CHANGE REQUEST

⌘ **23.012 CR 015** ⌘ rev **2** ⌘ Current version: **5.2.0** ⌘

Title:	⌘ Addition of ADD feature		
Source:	⌘ Ericsson L.M., Telefonica		
Work item code:	⌘ TEI6	Date:	⌘ 02/03/2003
Category:	⌘ B	Release:	⌘ Rel-6
	<i>Use one of the following categories:</i> F (correction) A (corresponds to a correction in an earlier release) B (addition of feature), C (functional modification of feature) D (editorial modification) Detailed explanations of the above categories can be found in 3GPP TR 21.900 .		<i>Use one of the following releases:</i> 2 (GSM Phase 2) R96 (Release 1996) R97 (Release 1997) R98 (Release 1998) R99 (Release 1999) Rel-4 (Release 4) Rel-5 (Release 5) Rel-6 (Release 6)

Figure 4.1.3.1 (sheet 2 of 3): Process Update_Location_HLR

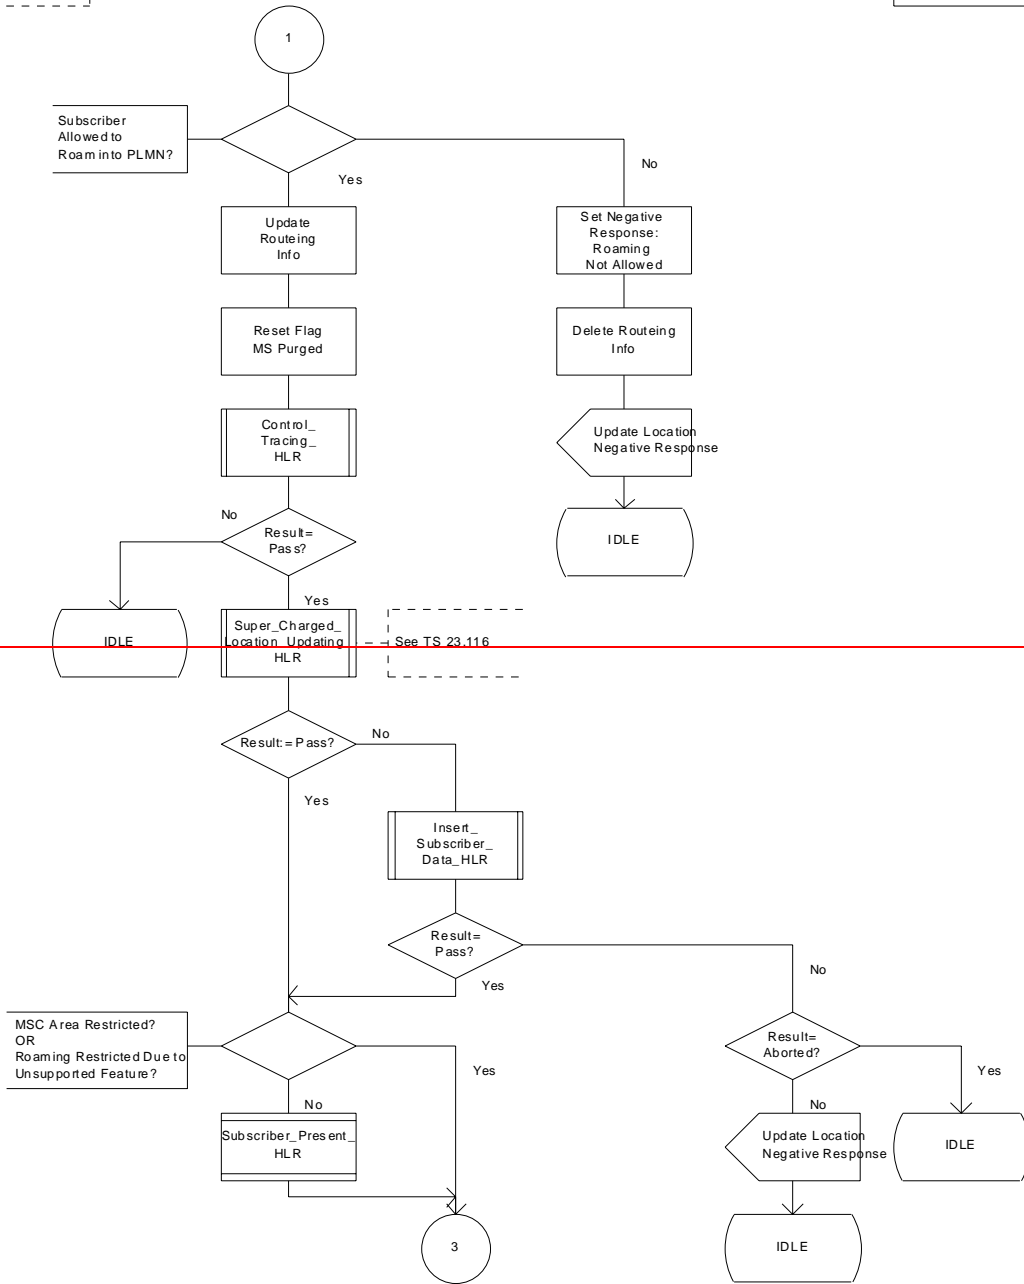
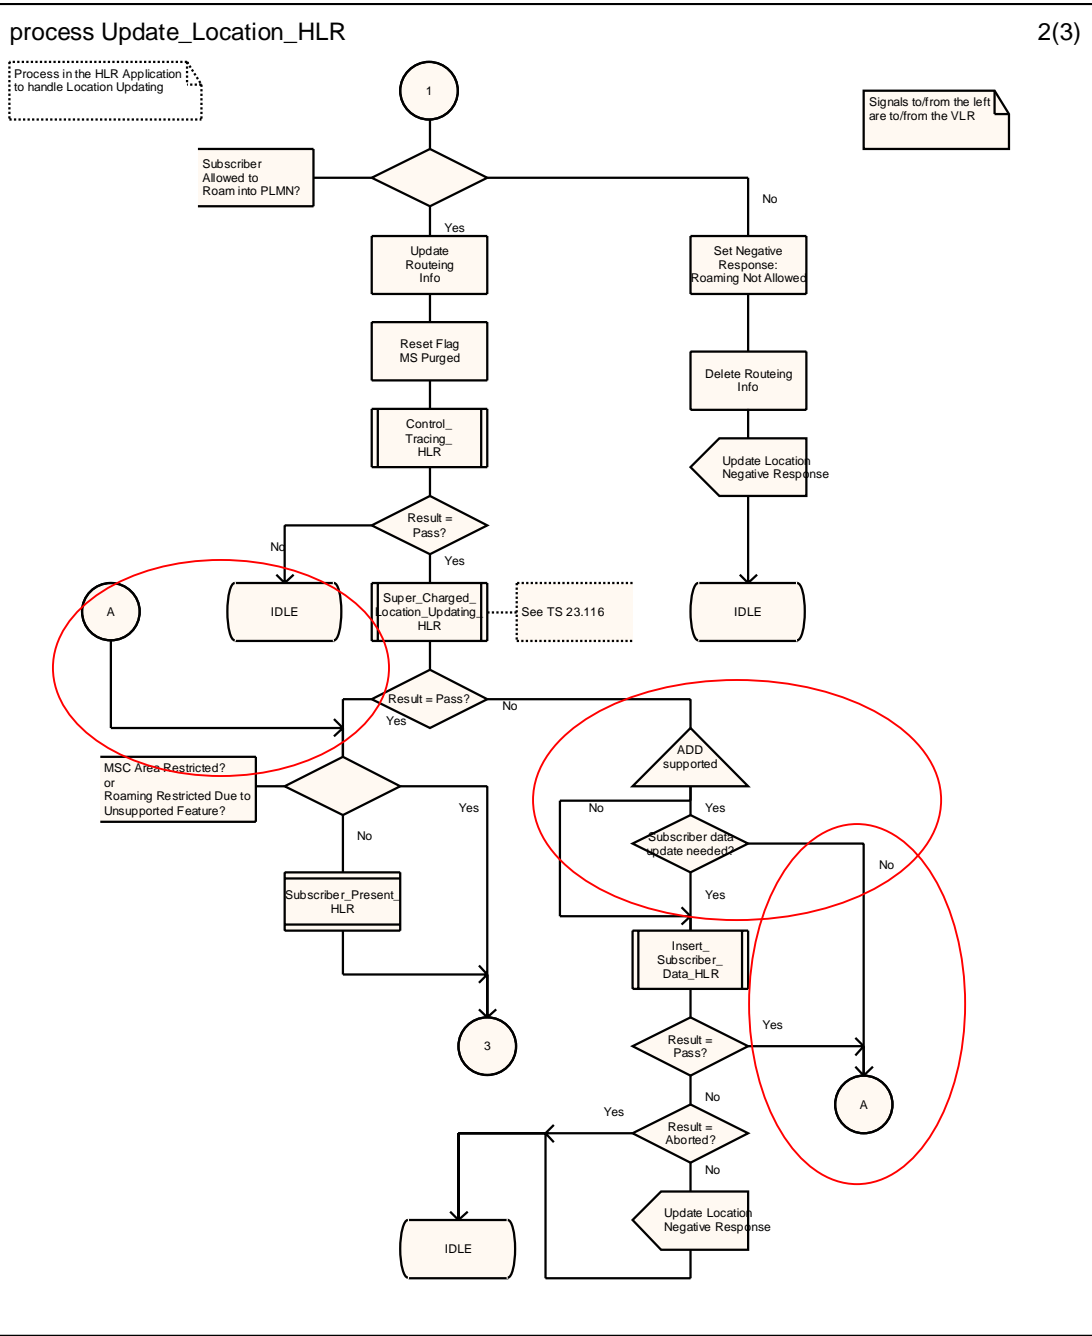
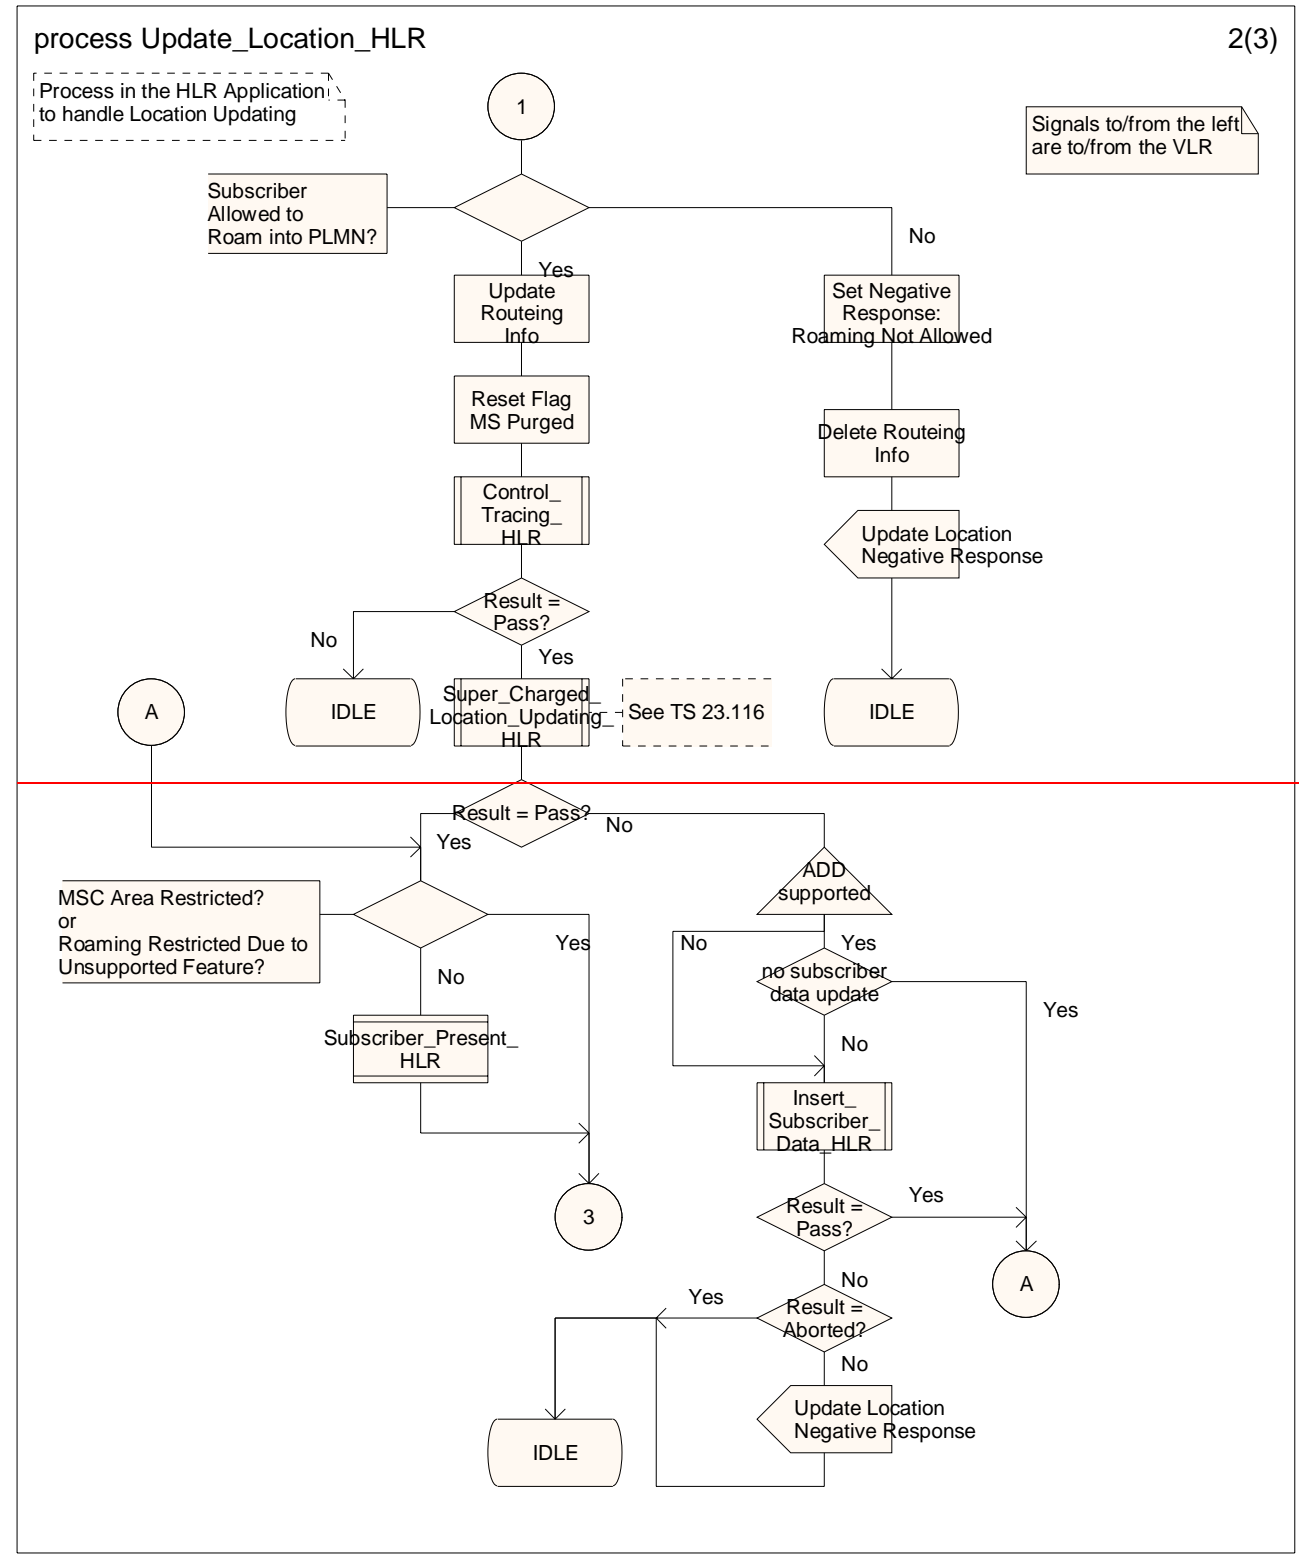
Sheet 2: The procedure Super_Charged_Location_Updating_HLR is specific to Super-Charger; it is specified in TS 23.116 [7]. If subscription data needs to be sent to the VLR, processing continues from the "No" exit of the test "Result=Pass?".

Sheet 2: The execution of the test “Subscriber data update needed?” is optional and depends on the presence of the relevant indication from the VLR. If no indication is received, then the result of the test is “Yes”.
